File No: 2019/578697
Our Ref: R/2017/25/A
Your Ref: SSD-8924 & SSD-8925

Request for advice – The new Sydney Fish Markets – Concept and Stage 1 (SSD-8924) and Stage 2 (SSD-8925)

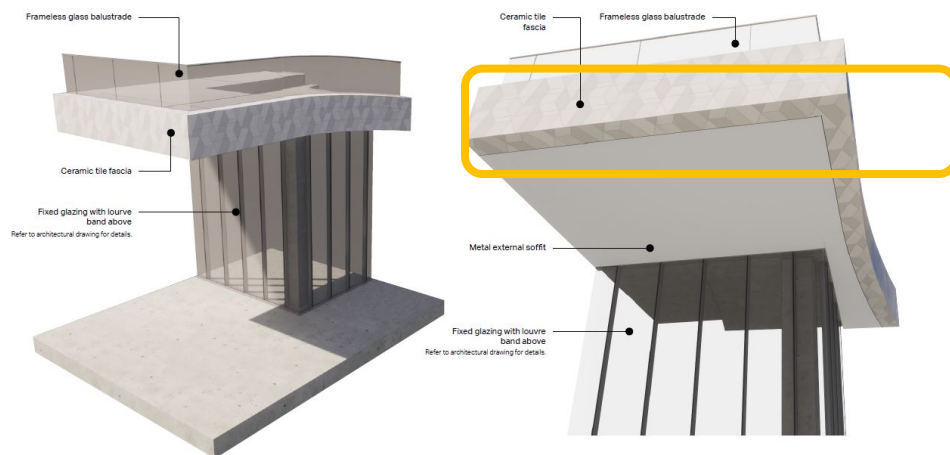
The key compositional element of the design is a 194m x 95m (approx.) undulating canopy roof that appears to float above the market. The roof structure is made from timber and aluminium panels studded with skylights. The roof has been designed to deliver a series of sustainability strategies including energy generation via integrated PV cells, rainwater collection, and natural ventilation using pressure differentials and indirect light penetration to the market.

The faceted timber roof structure provides a level of intricacy and authenticity that will enrich and add warmth and texture to the market and is considered successful.

The delivery of dappled light to the central east-west promenade and retail spaces is an intrinsic element of the scheme, and a function of the size and reflectivity of the south facing apertures, however, no material finish or aperture size has been identified for the important roof cassettes.

Maintaining the permeability of the canopy will be critical to the success of the scheme and its achieving design excellence. Ongoing consultation is recommended to ensure that any rationalisation of the roof structure to achieve commercial and sustainability outcomes preserve the permeability of the canopy, and the tactility of the faceted structure. Further information including a 1:20 section through the roof canopy is recommended to identify minimum/typical aperture size and materiality.

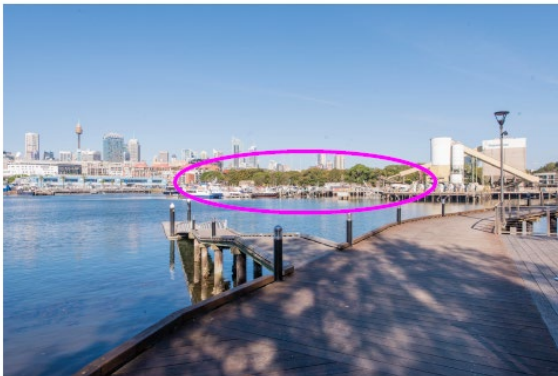
It is recommended that a Material Sample Board be provided to ensure that:

- The intricacy and energy of the patterned ceramic tile be achieved during design development.
- A high quality finish be achieved for the roof fascia that integrates with the edge treatment of the promenade below and throughout the development.
- A high quality finish be provided to the substations along the western side of the Bridge Road elevation.

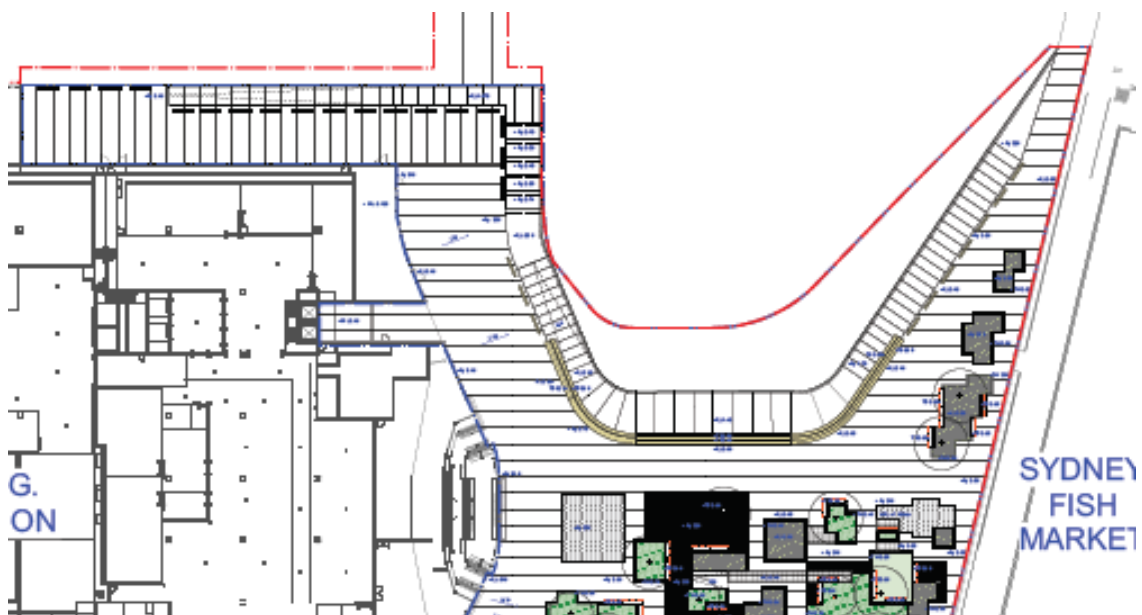
The foreshore promenade is elevated at the northwest corner to facilitate continuous operational functions below. The promenade consists of an outdoor seating zone and a public walkway. The outdoor seating zone illustrated on the Upper Ground Floor plan appears to be wider than the public promenade.

Given the natural value of Blackwattle Bay is a public asset, the generosity of the public part of the promenade is considered paramount, and should be realised as a generous public verandah with opportunities for recreation and rest beyond sitting at café / restaurant tables. ***It is recommended that a generous width of the raised walkway along the water's edge be for public use and not for use by commercial tenant seating. This should be formalised on title as a permanent right of public access for any leasehold or subdivided areas.***

Further, given the wind environment, it is noted that furniture elements as indicated on drawing 'Floor Plan Upper Ground Floor' AR-S2-B10 L01-01, should be fixed, and the addition of any elements should be subject to the recommendations of the Wind Assessment.

Figure 3-3 Eastern/Civic Plaza Drainage Network Setup in the TUFLOW Model

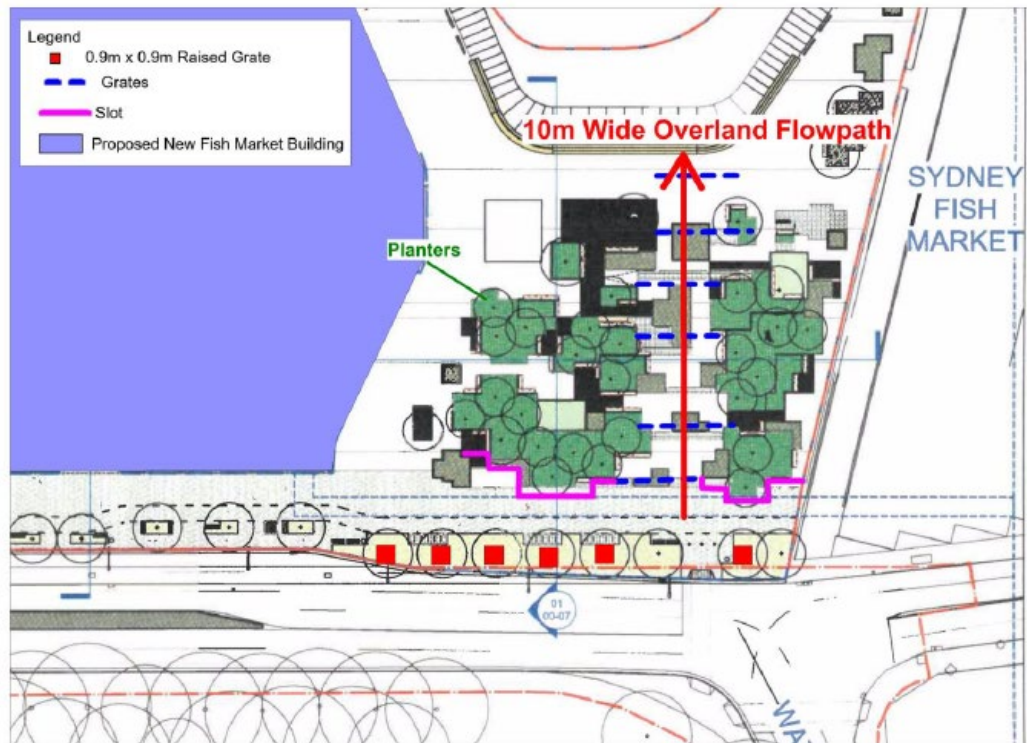
A 10-metre wide overland flow path exists at the termination of Wattle Street catchment at the northern edge of the eastern Plaza and waterfront promenade. The WSUD proposal includes a series of slots and grates connected to bioretention basins in tree pits to collect and convey stormwater flows. The slots and grates discharge directly into the bay below. The overland flow path conveys flows in excess of the capacity of the slots and grates through to the edge of the bay.

The Western and Eastern plazas are located at the low point of major stormwater overland flow path. There is insufficient information to determine the design, levels and potential impacts of stormwater, overland flow on the shared path and pedestrianised zones. It is not clear if the civil and flooding designs have been coordinated with the public domain design and additional information is required to determine if the public domain areas are designed for safety, mitigates trip hazards, provides effective best practice WSUD and a robust, seamless, high quality landscape and design excellence within the public domain.

The stormwater and WSUD design should be more fully coordinated with the public domain plans, sections and details to show the full extent of stormwater infrastructure, devices and impacts on landscaped zones in the public domain. The City requests that the proponent to clarify if site intensification and proposed uses will increase stormwater discharge loads into Blackwattle Bay, submit coordinated public domain plans including levels (IL, RL, TW, SSL) and details and submit an amended stormwater management plan, showing location of all pits and WSUD devices and interface with adjoining surfaces in the Western Plaza, shared path and signal crossings.

Figure 3-4 Western Plaza Drainage Network Setup in the TUFLOW Model

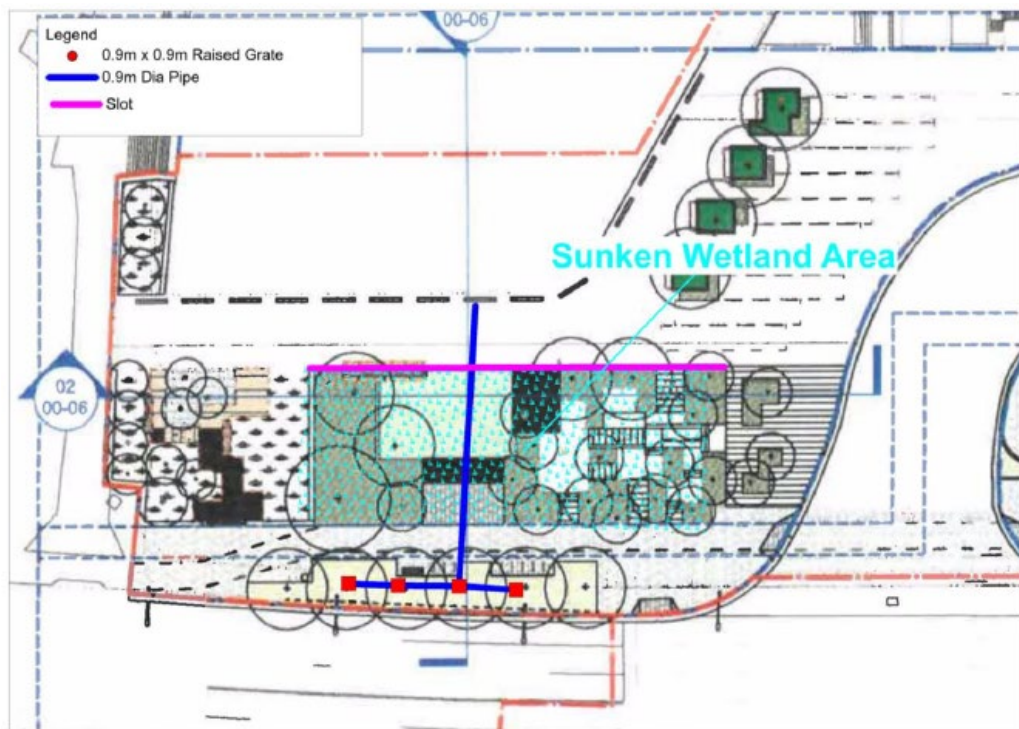
The “Western Plaza” opposite Wentworth Park Road intersection includes raised pits in the bioretention zone / tree pits and a sunken wetland in the public domain, either side of the shared path, to slow overland flow and floodwater prior to discharge into Blackwattle Bay.

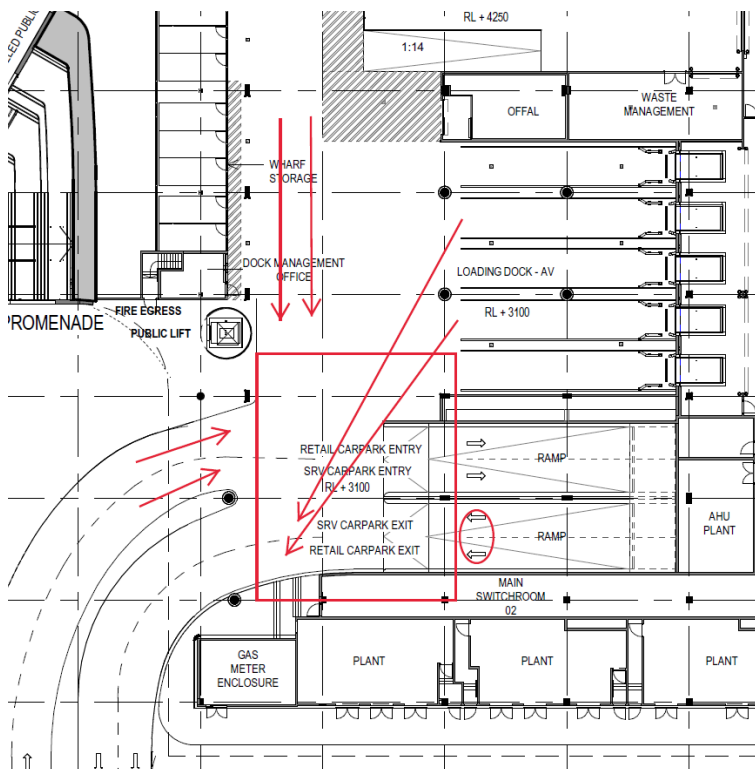
A review of the submitted drawings show the following service vehicle parking spaces within the premise:

- 5 X 19m long semi-trailer AV (ground level loading dock);
- 13 X 8.8m long medium rigid vehicle (MRV ground level loading dock); and
- 3 X 6.4m long small rigid vehicle (SRV ground level *loading dock*).

Concern is raised regarding vehicle movement at the confluence of the loading dock access point and the basement entry ramp, particularly for longer vehicle manoeuvring. This should be investigated in details by a qualified traffic engineer, confirmed with vehicle swept path analysis. It is noted that this space may require a traffic light/ other management measures details of this investigation are to be provided for consideration.
